711 HUNTER ST, NEWCASTLE

DEVELOPMENT APPLICATION RFI
DESIGN RESPONSE REPORT

19th of May 2023

TYPICAL CAR PARKING LEVEL

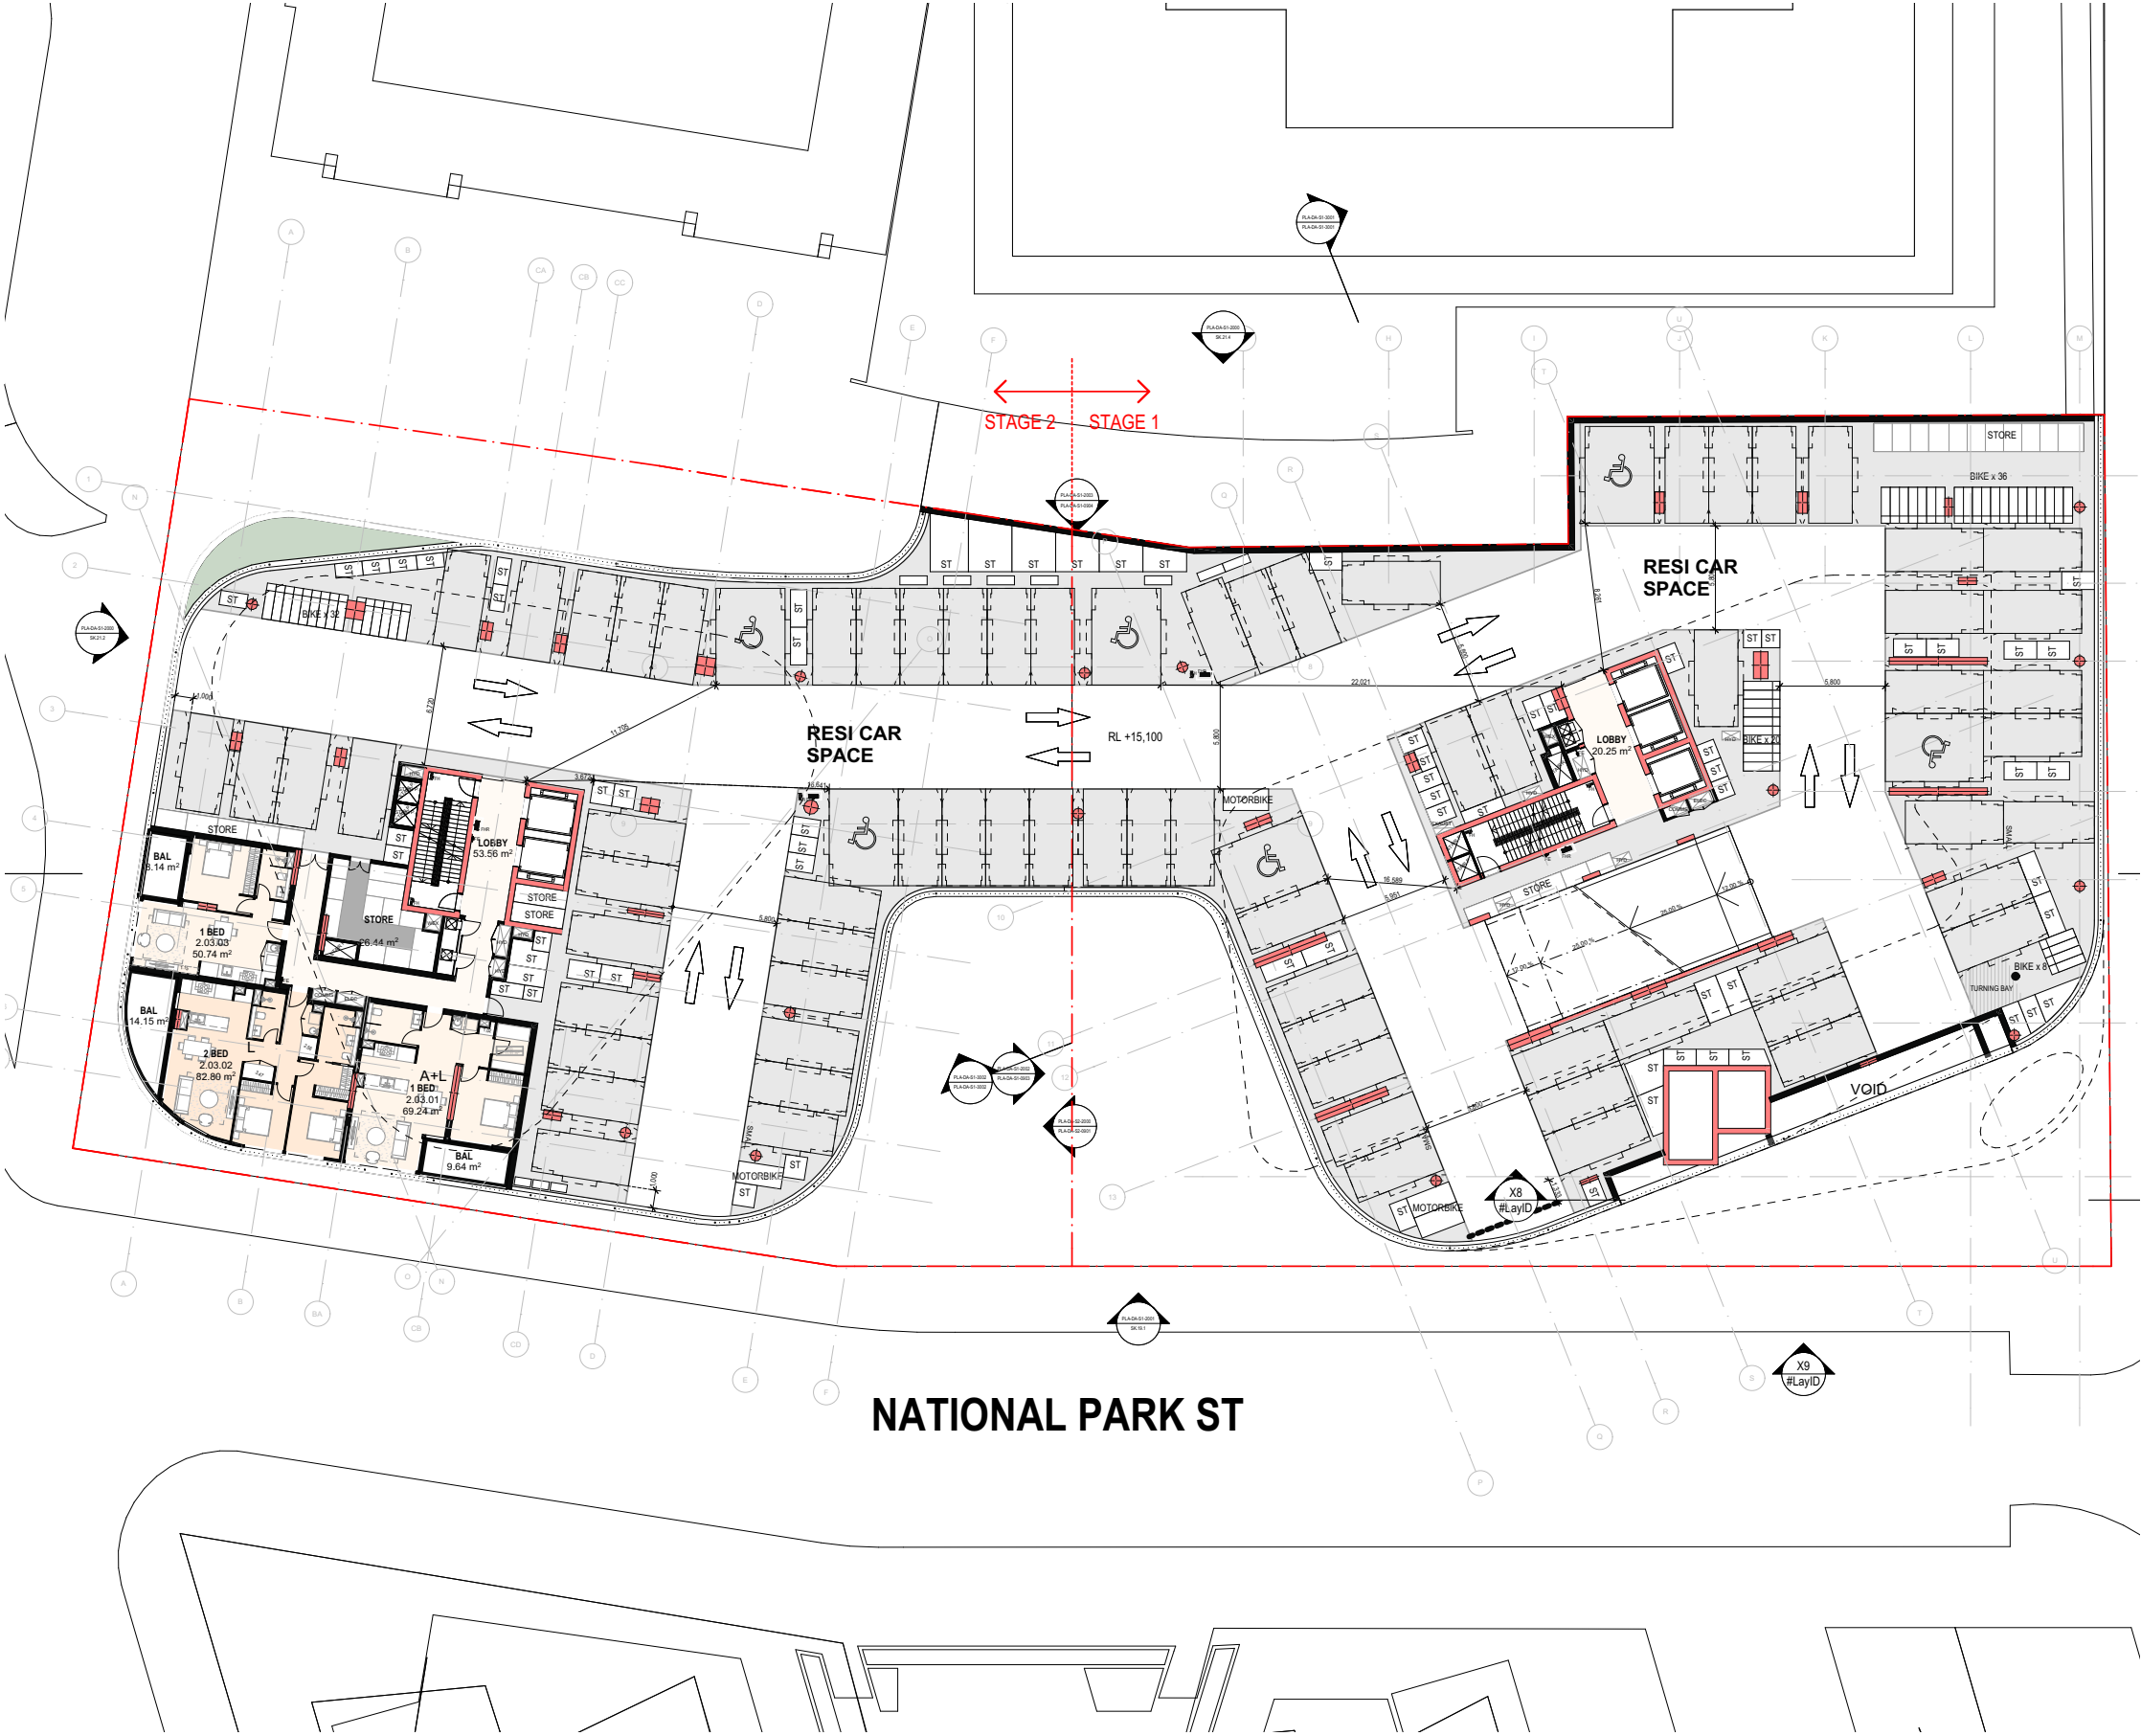
NO	RESPONSE	RESPONSE TO SUBMISSION	SUPPLEMENTARY MATERIAL
7	ENGINEERING MATTERS		
D	<p>Splay:</p> <p>Amended plans are required which detail a 3.0m x 3.0m splay, the splay is required at the corner of National Park Street and Hunter Street. The application should be amended to propose splay and dedication as future road reserve.</p>	<p>A 3.0m x 3.0m splay has been detailed at the corner of National Part Street and Hunter St on the architectural floor plans</p>	<p>Refer to Engineering Matters page 37</p>
E	<p>Car park layout:</p> <p>Car park bays and aisle widths on plans are to be dimensioned to confirm compliance with AS 2890.1 – Off-street Parking Facilities. Further, disabled parking bays should be located and identified within proximity of proposed lifts and must be clearly illustrated on the submitted plans.</p>	<p>Car parking levels 1-4 have been updated to include dimensions of car parking manoeuvring spaces, including distance of travel for disabled parking bays to lift lobbies.</p>	<p>Refer to Engineering Matters page 39</p>

Car Park Layout:

Adequate clearances are provided for vehicular manoeuvring. Additional dimensions of car park aisles and proximity of accessible car spaces to lift lobbies are provided to each car parking level. Refer to Architectural drawings for dimensions to each car parking levels 1-4

LEVEL 5 - LANDSCAPE PLAN

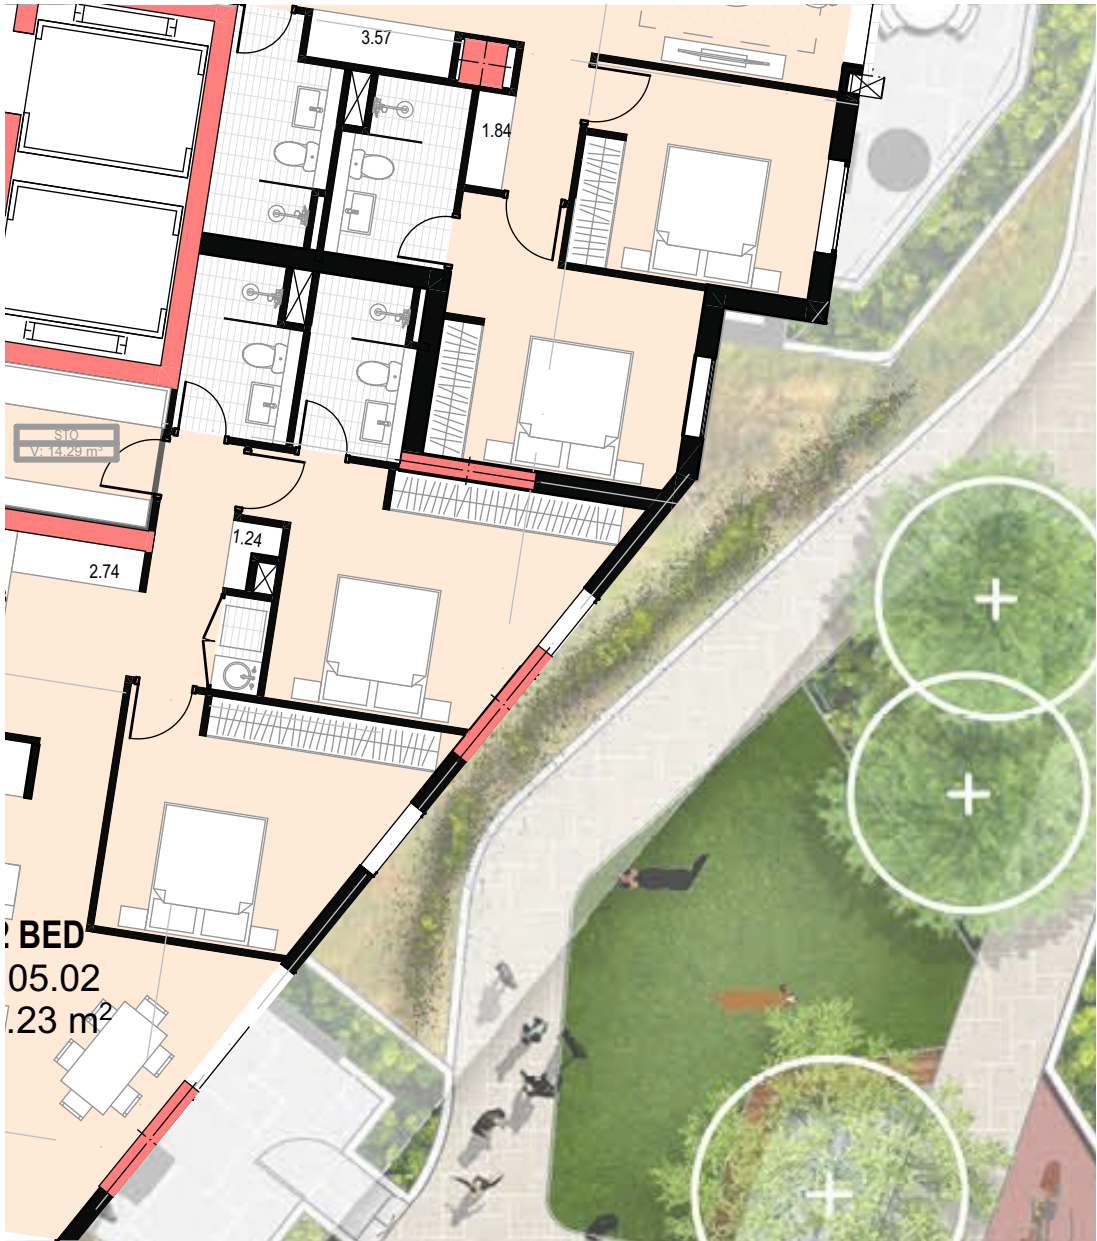
NO	RESPONSE	RESPONSE TO SUBMISSION	SUPPLEMENTARY MATERIAL
1	CONTEXT AND NEIGHBOURHOOD CHARACTER		
	<p>It was noted that the design of the podium was modified following the design competition, which involved the introduction of extensive residential accommodation on the common podium – which previously entirely devoted to landscape and communal space for residents. The DIP has made recommendations in respect to this area, and a revised design has not as yet been received in response. The UDRP has raised a number of issues pertaining to this area, and awaits the mooted design revisions</p>	<p>The design allows for 31% communal open space, significantly more than the 25% required as per the ADG.</p> <p>Improvements are proposed to the private open space through the extension of the proposed awning structure over the private open spaces with increased planting opportunity for trees on the edge. This provides a green canopy which significantly improves the greening of the podium as viewed from both the apartments above and from the street, whilst minimising privacy impacts on the deck.</p>	<p>Refer to Level 5 Podium Design page 42, 44-45</p>

3	LANDSCAPE		
	<p>It was noted that the Designing for Country documentation prepared by COLA envisaged an integrated landscape treatment that visually connected the podium level to the ground plane with vegetation in a number of locations, including the north-east corner (National Park St/ Hunter St corner) and the south-west corner adjacent to the Drill Hall. The extensive podium level soft landscape proposed in the Competition design was an integral part of this, and the design development identified by the DIP needs to take into account how the Design for Country vision can be successfully implemented. Towards this end, the leafy landscape character of the podium and the cited connections to ground needs to be reinstated.</p> <p>While the introduction of residential accommodation to the podium level is not opposed in principle, the reduction of landscape and the consequential close juxtaposition of public and private areas requires further consideration. For example, the NW corner of the communal open space and the proposed dwelling bedrooms are a potential conflict and need to be further developed, and near the southern tower, the close proximity of the running track and dog exercise area needs to be reconsidered, in favour of greater soft-landscape buffer areas.</p> <p>Very extensive hard-paved private open areas associated with the introduced residential component at podium level are inappropriate for a range of reasons. They do not support the Design for Country vision, they lack privacy for residents, they are excessive in area, and contribute to heat island effect. These areas do not provide an attractive green foreground area for residents of the subject towers or their neighbors that overlook the podium</p>	<p>The amendments proposed for north-east corner (National Park St/Hunter St) involves incorporating additional trees along the podium edges. This creates a lush green canopy that adds another layering to the greenery proposed to the generous green planter edges already proposed. This significantly enhances the podium's greening and conceptually reinforces the rich landscape character and layering envisioned with Design for Country.</p> <p>The landscape design has been improved to include a landscape buffer as well as a green screening strategy which provides privacy between the communal and proposed dwelling bedroom windows, whilst minimising the solar and visual amenity of the residents from within their internal spaces.</p> <p>The amendments include the extension of awning cover, the addition of trees for the private open spaces, reducing the amount of hard-paved areas and providing both architectural and landscape interventions for shade and screening. This aligns with the Design for Country vision by providing a green foreground that enhances privacy for residents, reduces excessive paved areas, and mitigates the heat island effect. This integrated approach ensures an attractive and environmentally conscious environment for both residents of the towers and neighboring properties overlooking the podium</p>	<p>Refer to Level 5 Podium Design page 42, 44-45</p> <p>Refer to Level 5 Podium Design page 42-43</p> <p>Refer to Level 5 Podium Design page 42, 44-45</p>

Additional interventions are proposed to address privacy and greenery to the L5 podium levels.

Particular concern to the privacy between bedroom windows to the communal open spaces have been addressed as well as the privacy and greening of the private open spaces towards National Park and Hunter Streets.
